Product Change Notice

(PCN Tracking Number: EE-QR-220119-01) Version: 1

Customer:	ALL Customers					
Renesas Product Type:	M16C & M32C. Refer to separate file "Product List & Change Scenario.xlsx"					
Description of Change:	Change of die attach material, lead frame and production factory (pages 2-4)					
Reason for Change:	Due to the end of supply by the material manufacturer					
Identification:	Identifiable via production history data from the trace code					
Schedules:	Sample order deadline: e/o Jan. 2022 Sample delivery: b/o May 2022 (upon request) Reliability report: available (upon request) Requested approval e/o Oct. 2022 Change Implementation b/o Jan.2023					
Anticipated Impact:	<table style="width: 100%; border: none;"> <tr> <td style="padding: 0;">Fit, Form & Function:</td> <td style="padding: 0;">No change</td> </tr> <tr> <td style="padding: 0;">Quality & Reliability:</td> <td style="padding: 0;">No impact</td> </tr> </table>		Fit, Form & Function:	No change	Quality & Reliability:	No impact
Fit, Form & Function:	No change					
Quality & Reliability:	No impact					
Doc. No.:	EEQC-PCN-CR-22-0039					
Internal Reference:	IMO-AZ-21-0003-1

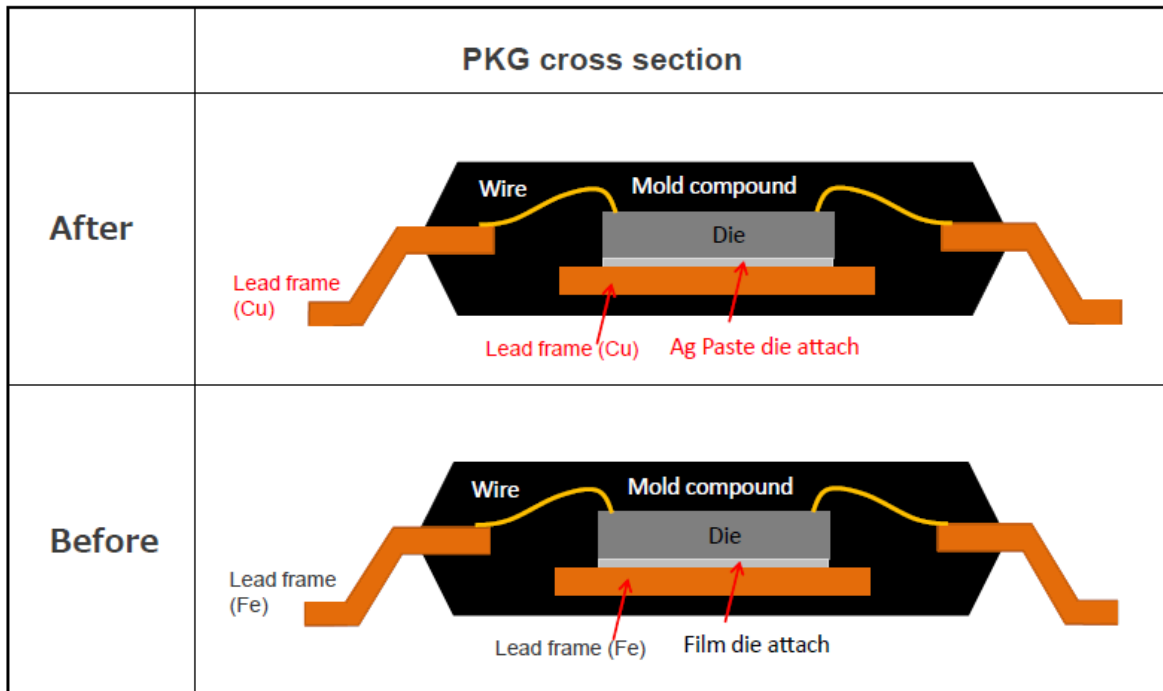
Die attach material: (Film →Ag paste)

Lead frame: (Fe →Cu, no change in shape.)

Item		Before	After
Die attach material	material	Film die attach	Ag paste die attach
Lead Frame	Raw material	Fe	Cu
Shape		No Change

Package Structure (example):

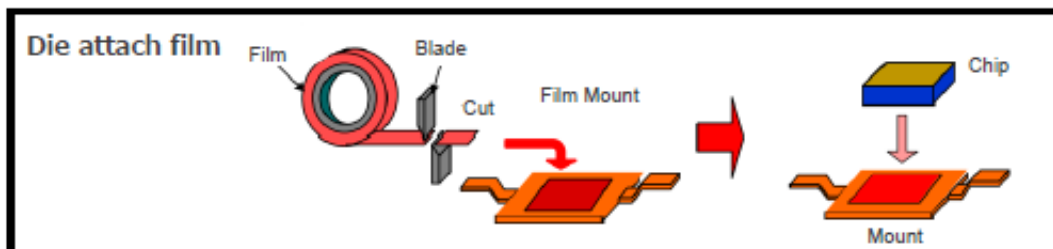
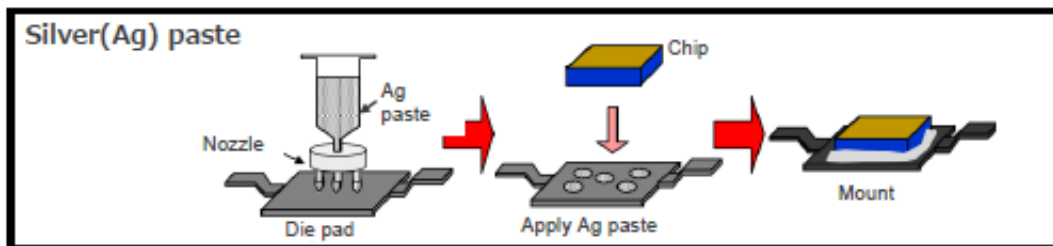
Ag Paste /Die Attach Film Process (Image):
